Texas Commission on Environmental Quality Waste Permits Division Correspondence Cover Sheet

Facility Name: Lacy Lakeview Recycling and Disposal Facility

Permit or Registration No.: MSW-1646B

**Subject: Supplemental Revisions
Permit Amendment Application, Proposed MSW Permit No. 1646B
Lacy Lakeview Recycling and Disposal Facility
Waco, McLennan County, Texas
Tracking No. 27941547**

PROJECT NO.: GW8041	DESIGN BY: SMG	REVIEWED BY: YB	PART NO.:	DRAWING:
FILE: GW8041PI-IIA-25	DRAWN BY: JJV / KH	APPROVED BY: SMG	I/II	I/IIA-24

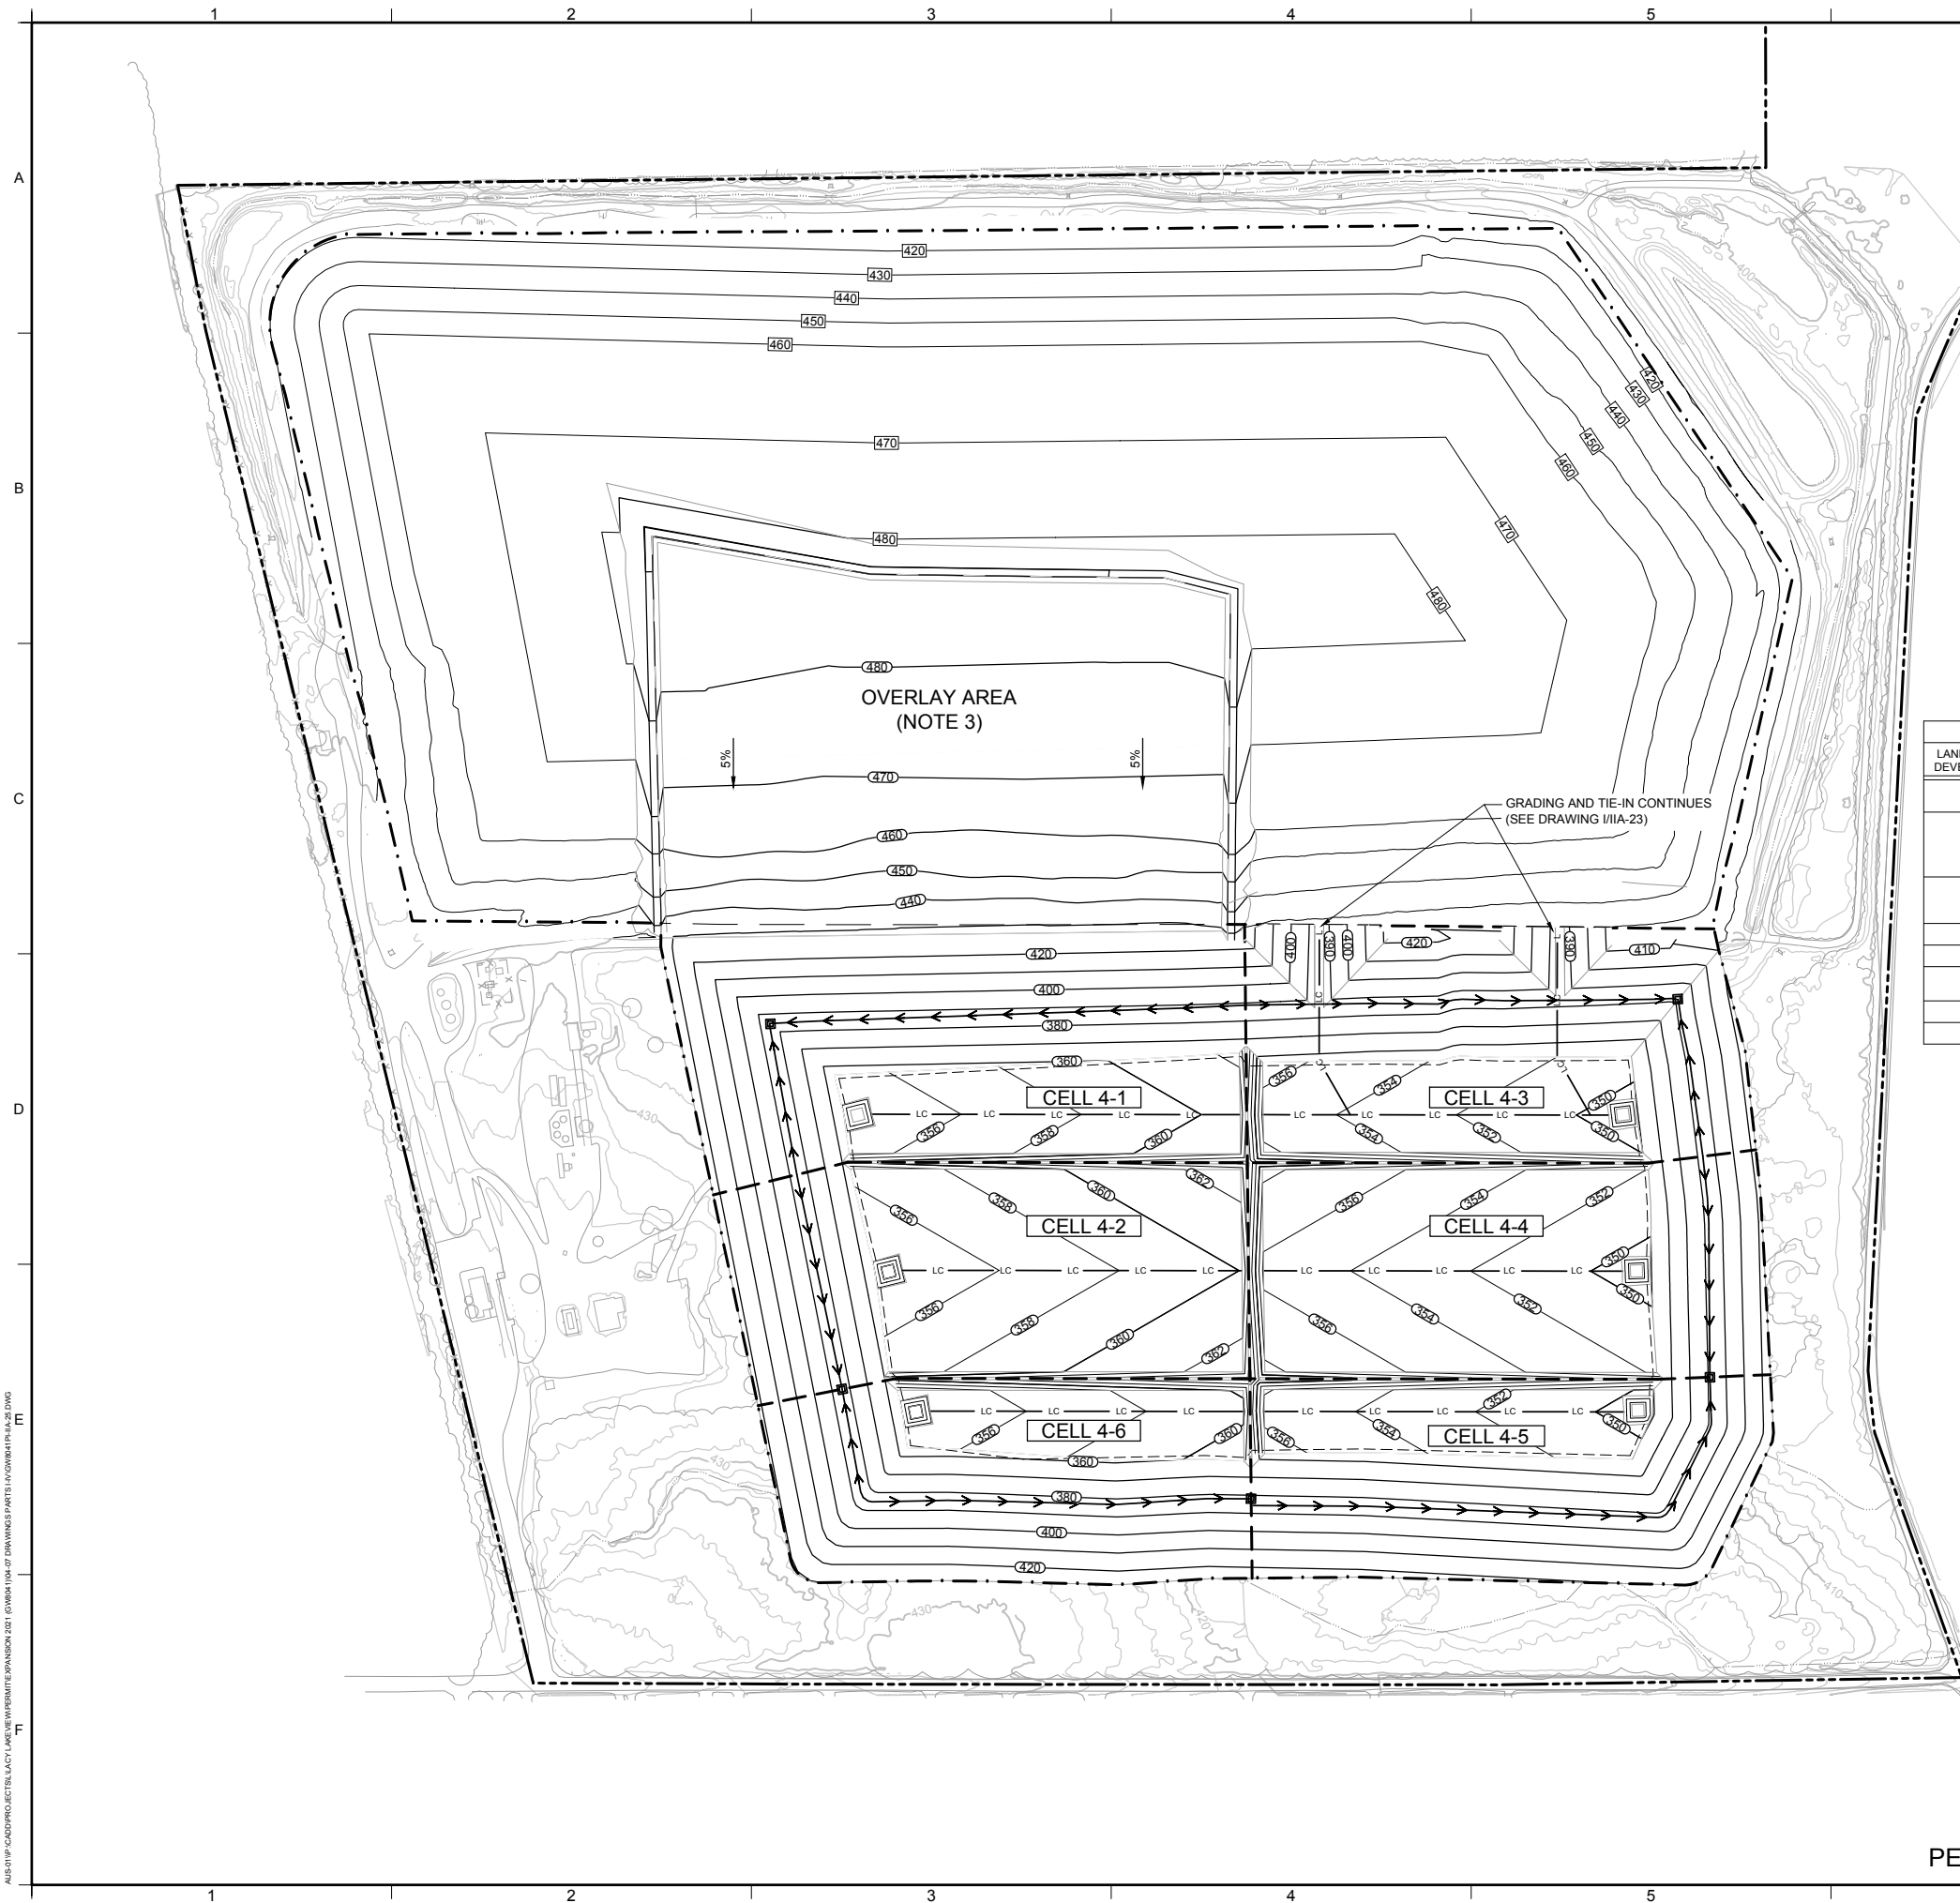
- Change to the first waste filling sequence, affecting Part I/II, Appendix I/IIA, Drawings I/IIA-24 and 25; and Part III, Attachment 3A, Drawing 3A-4. The requested revision is to include the allowance to conduct waste filling (placement) in selected areas of the top-deck of the existing landfill during the first interim filling stage (i.e., after approval and issuance of Permit No. 1646B). The waste placement area would be in areas designed with a 100-ft (min) set-back from the future overlay area and the leachate sump tie-in excavation limits, so as not to interfere with or affect associated construction in those areas. A filling plan (grading and layout) for this revision has been designed accordingly, adhering to these work-area set-backs and compatible with the final grading geometry, stormwater management, and stability – with these grades added to Drawing I/IIA-25. Also for consistency of the described waste placement activities, the last column of the first row of the table on Drawings I/IIA-24 and 3A-4 has been revised with the descriptor of this filling area. This requested change will help maintain continuity of waste placement after issuance of Permit No. 1646B by providing disposal capacity during the time when the first expansion area cell is being constructed.
